**POLARIS****TECHNICAL SERVICE BULLETIN**

Bulletin Number: A-17-01-E

***** BULLETIN A-17-01-E Supersedes ATV-15-02/A *******SUBJECT:****2015 Sportsman 1000 1-Up Thermal Protection and Silencer Spring / Seal Update****PURPOSE:**

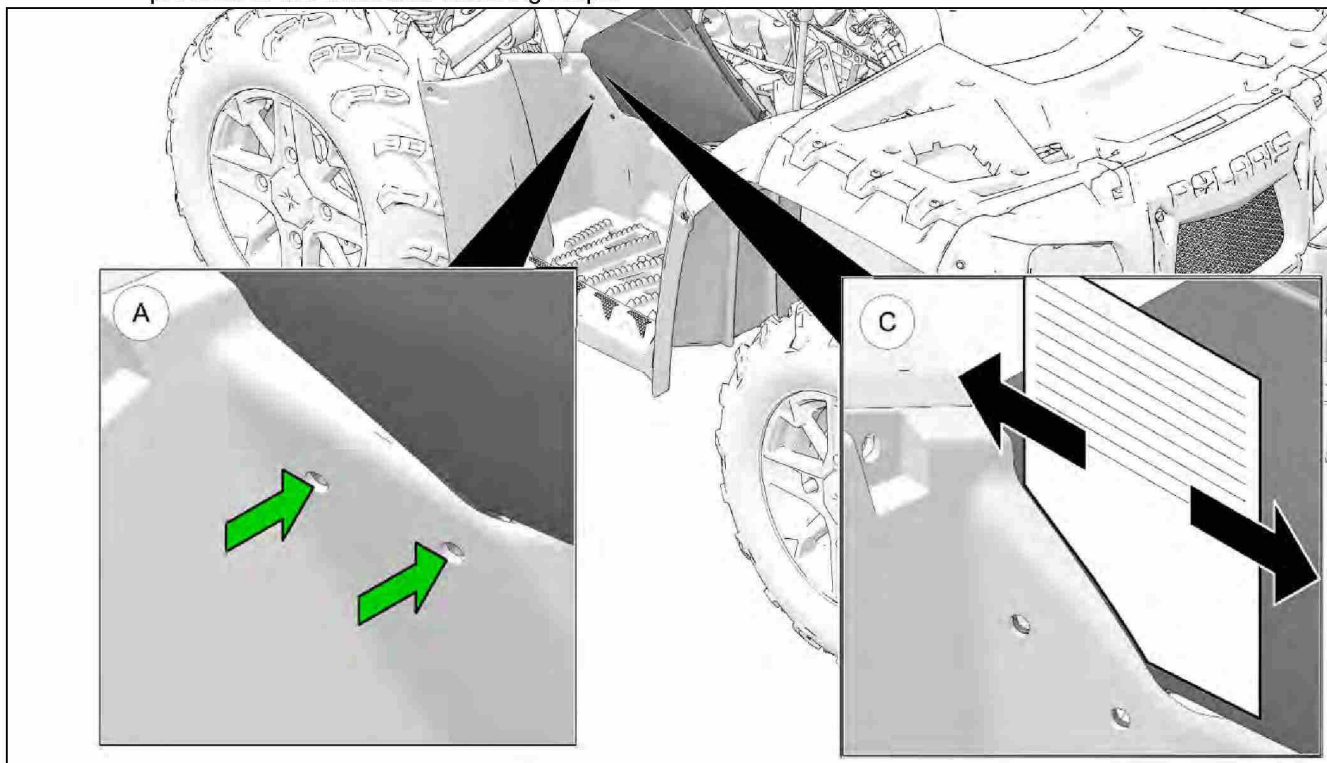
5. Using a DREMEL® with a two flute bit intended for plastics, a reciprocating saw or similar device, trim the footwell corner in line with the template (area circled in red shown in the **Before** and **After** images below).

Before

After

- Test fit the new panel to verify the footwell area trimmed does not contact the exhaust manifold side panel when the lower mounting surface is contacting the footwell.
- Align the mounting holes.
- Press the exhaust manifold side panel against the footwell applying pressure at or near the holes.
- Slide a piece of paper along the gap between the two panels.
 - If the paper slows or stops or the metal shield makes contact with the footwell, use a half-round file to trim the footwell to create a clearance gap between the components.
 - If the paper freely travels the length of the gap, and the metal shield does not contact the footwell, proceed to the audit and following steps.

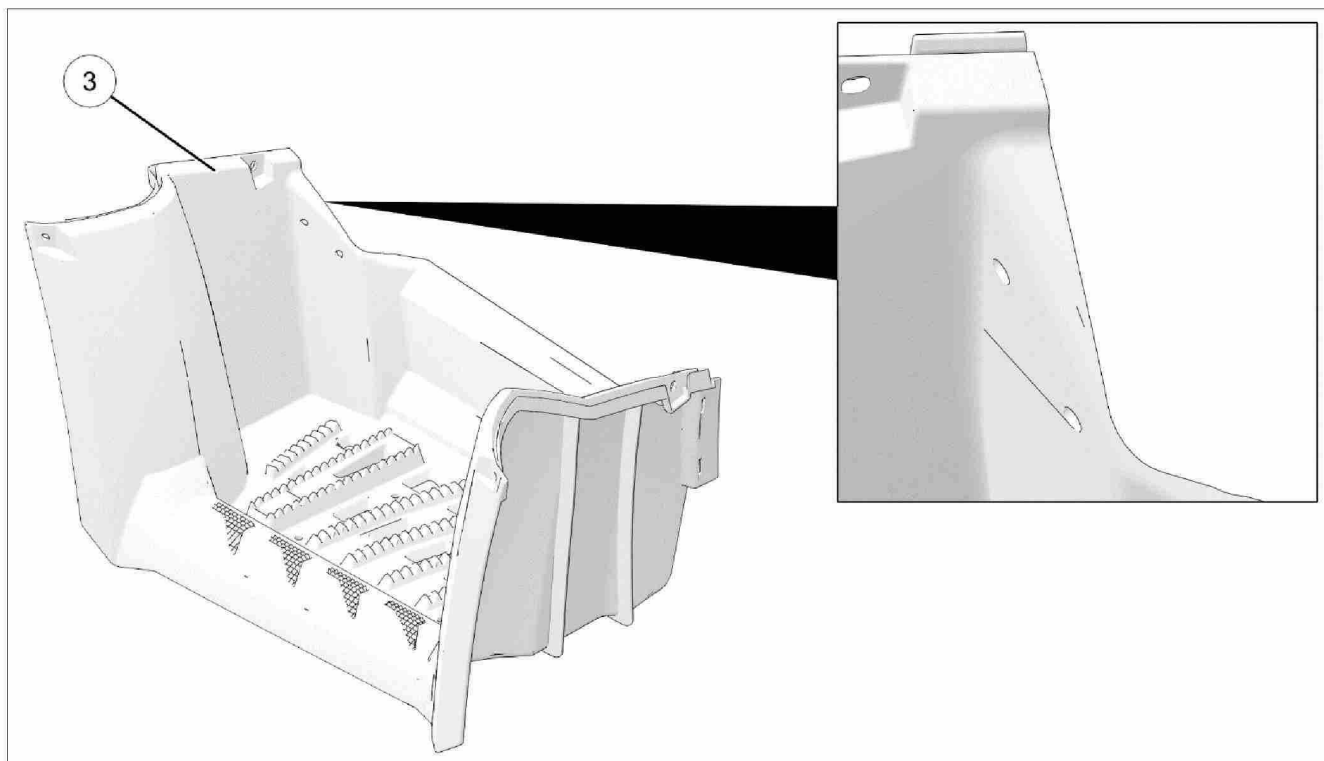
A secondary dealer representative must verify that the trimmed edge of the footwell does not contact the new exhaust manifold side panel.

If a piece of paper does not freely slide between the panels, continue to trim the panel using a half round file until the paper passes freely the entire length of the gap.

6. Using a half-round file, file and deburr the trimmed footwell ③. Ensure the footwell is clean, free of burrs, and maintains rider appeal. Verify trimmed area appears as shown in the illustration below.

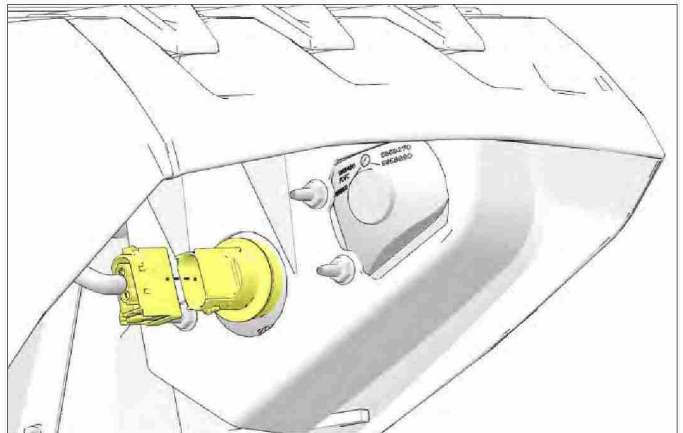
A secondary dealer representative must verify the Rear Cab Heat Shield is bent down and wraps around the corner of the Storage Box and Tail Light Harness. If it interferes when installing the cab, ensure it is bent back down to match the good example below.

Acceptable – Rear Cab Heat Shield encloses the corner of the storage box and harness

Unacceptable – Rear Cab Heat Shield interferes with the storage box and harness
